**SECTION 4.55(1A) MODIFICATION REPORT
TO AMEND SSD-81623209**

9-21 Beaconsfield Parade, Lindfield

March 2026

Submitted to the Department of Planning, Housing & Infrastructure

Figure 3: Proposed Basement 02

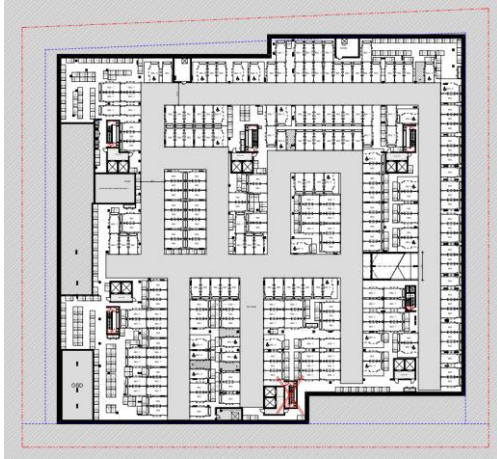
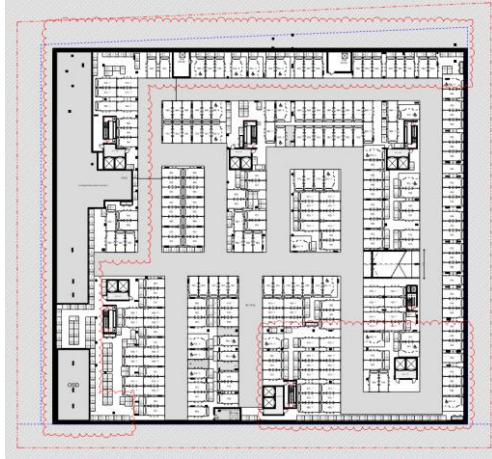
PROPOSED MODIFICATIONS	
Basement 02	
<ul style="list-style-type: none"> - Minor adjustment to the north-east corner resulting in a reduced basement extent in this location. - Extension of the south-east corner resulting in an increased basement extent in this location. - Car parking layout amended to respond to the revised basement footprint. - Car park configuration rationalised to improve vehicle circulation and manoeuvrability within the new basement footprint. - Relocation of storage areas within the north-west corner, with overall storage provision maintained.

<ul style="list-style-type: none"> - Residential car parking increased from 150 (approved) to 160 (proposed). - Residential accessible parking reduced from 26 (approved) to 24 (proposed). - Residential tandem parking reduced from 70 (approved) to 64 (proposed). - Total carparking increased from 246 (approved) to 248 (proposed) - Fan room area adjusted to align with the revised basement footprint.
<p>Basement 01</p> <ul style="list-style-type: none"> - Minor adjustment to the north-east corner resulting in a reduced basement extent in this location. - Extension of the south-east corner resulting in an increased basement extent in this location. - Car parking layout amended to respond to the revised basement footprint. - Car park configuration rationalised to improve vehicle circulation and manoeuvrability within the new basement footprint. - Relocation of storage areas within the north-west corner, with overall storage provision maintained. - Residential car parking reduced from 135 (approved) to 126 (proposed). - Residential accessible parking reduced from 25 (approved) to 16 (proposed). - Residential tandem parking reduced from 60 (approved) to 50 (proposed). - Dedicated (1) car wash bay. - Dedicated (4) car-share bays - Dedicated visitor car spaces (24) and one (1) visitor accessible parking spaces. - Total carparking increased from 220 (approved) to 222 (proposed) - Bin holding room reconfigured, portion of the area has been lowered from RL 79.60 to RL 78.00 to provide better level access for waste collection vehicles. - Dedicated FOGO holding areas introduced adjacent to each core. - Fan room layout adjusted to align with the revised basement footprint. - Deep soil area increased from 2,790m² or 20.8% (approved) to 2,926m² or 21.9% (proposed) in 6m wide deep soil zones.

Figure 11: Proposed Section 02

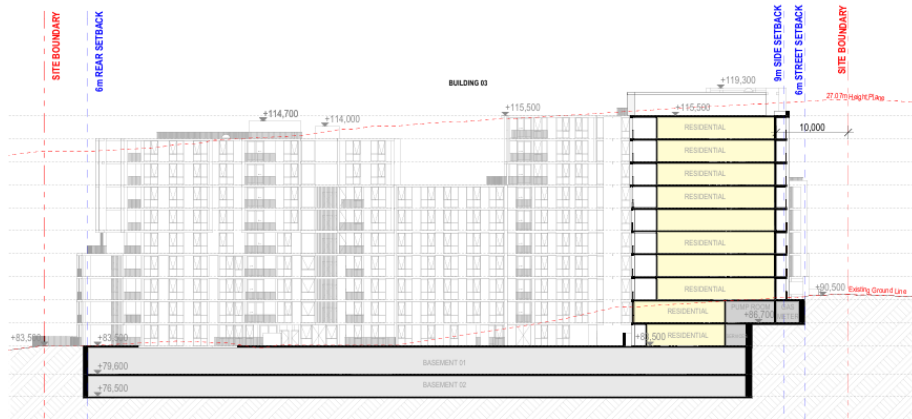
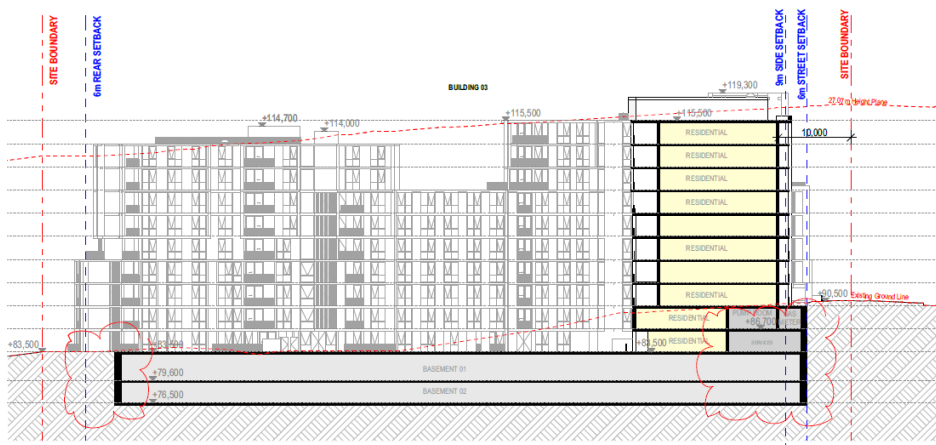
This Section 4.55(1A) modification application seeks consent to amend the approved drawings to reflect minor design modifications relating to the basement design. The main amendment removes unnecessary stepping in the basement footprint to enable a contiguous shoring design. All changes are confined below ground and do not alter the approved built form or external appearance.
